Comment Date: January 26, 2012 23:56:11PM  
Supplement to the Draft Solar PEIS  
Comment ID: SEDDSupp20100

I appreciate the opportunity to submit comments to the Bureau of Land Management (“BLM”) on the Supplement to the Draft Programmatic Environmental Impact Statement for Solar Energy Development in Six Southwestern States (“Supplement to the Draft PEIS”). I am submitting these comments as someone who cares deeply about preserving our precious Western ecosystems and wild lands. However, I also have a strong commitment to halting climate change and ending our dependence on fossil fuels.

**Appendix A:** Proposed wilderness areas and Special Management Area that should not be included in variance zones.

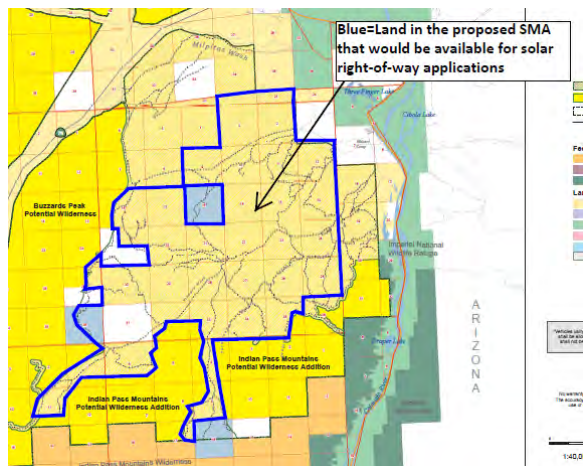
We thank the BLM for deleting the proposed Iron Mountain SEZ, and for recognizing concerns about this SEZ that were raised by numerous stakeholders including conservation organizations, solar industry developers, utilities and others. We also thank the BLM for identifying the proposed Iron Mountain SEZ as an “exclusion area” in Table 2.2-1 (SPEIS at p. 2-17). The area’s extremely high value wilderness and other resources coupled with the lack of nearby or planned transmission amply justifies this decision. We remain concerned, however, that substantial acreage within the Citizens’-proposed Iron Mountain Wilderness, which partially overlaps the former SEZ, remains open to variance applications; we request that this area be added to the list of exclusion areas. Please see our comments and a map showing the overlap in Appendix A.

**Bighorn Mountain Proposed Wilderness Addition**

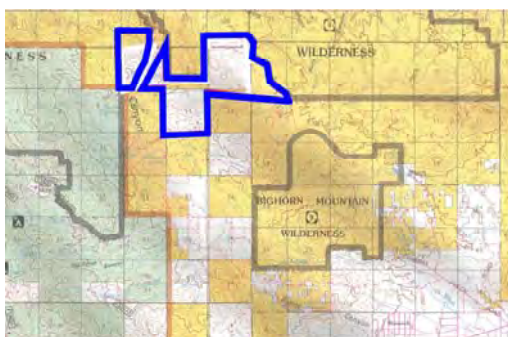
There are several small parcels of proposed variance areas scattered across approximately 1,620 acres of this proposed wilderness addition.

We request that the proposed wilderness addition be excluded from the variance zone because this

### **Iron Mountain Proposed Wilderness**

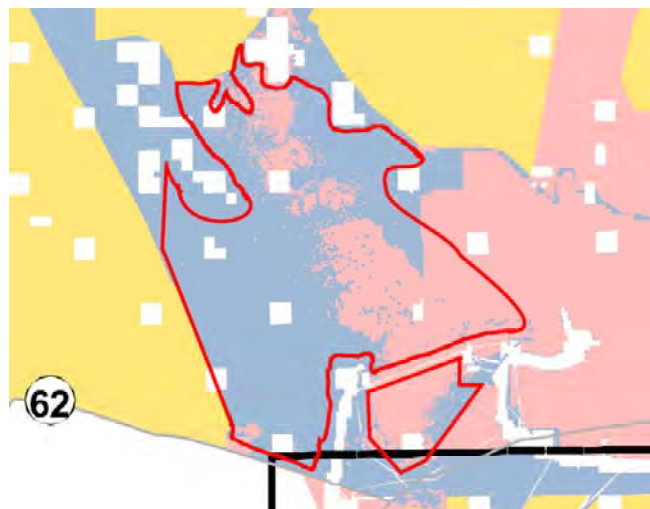
left, there is substantial acreage of proposed variance areas scattered across the majority of this proposed wilderness.

We request that the proposed wilderness addition be excluded from the variance zone because the region is a critical habitat corridor between the Old Woman Mountains Wilderness and the Sheephole Wilderness for Nelson's bighorn sheep. Other sensitive species known to live in the area include desert tortoise, Alverson's foxtail cactus, Harwood's eriastrum, small-flowered androstephium, Mojave fringe-toed lizard, prairie falcon and hepatic tanager. In the years ahead the importance of the proposed wilderness as both a corridor and as core habitat will continue to grow as lands to the south and east of Iron Mountain may be developed. Much of the proposed variance area between the Kilbeck Hills and the Iron Mountains currently consists of vast sand dunes that are also inappropriate sites for development because of the ecological importance shifting sands play in the Mojave Desert's ecosystem.

### **Palen-McCoy Proposed Wilderness Additions**

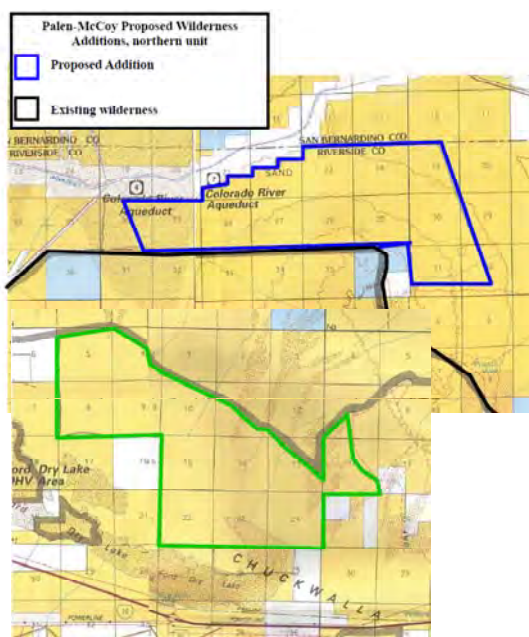
One of the remaining areas that has not yet been protected as wilderness is on the north (approximately 7,000 acres) and the other is on the south
